SERVICE BULLETIN

BULLETIN	ISSUED	MODEL(S) AFFECTED	SUBJECT(S)
SBM01-05	11/8/01	2001 X440s, 2002 X440s, See list on page 5., And, units installed with the MC1000 Update Kit (P/N 913-5002053)	1 - MC1000 operating code 2 - Hard starting and cold start

MC1000
Engine Control Unit (ECU)

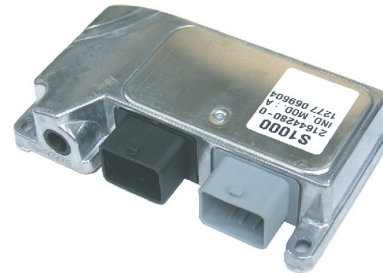
(1) Field reports of intermittent engine stalling have been attributed to early releases of the MC1000 ECU operating code. The operating code is something like the operating system in an ordinary personal computer or PC (example: Windows 95). The operating code should not be confused with the calibration file; that file contains mapping and vehicle specific calibrations.

SOLUTION : (1) For condition 1 above, a revised version of the MC1000 operating code has been developed and must be installed on all affected models. A special MS-DOS program has been developed to install the revised code file to the vehicle ECU.
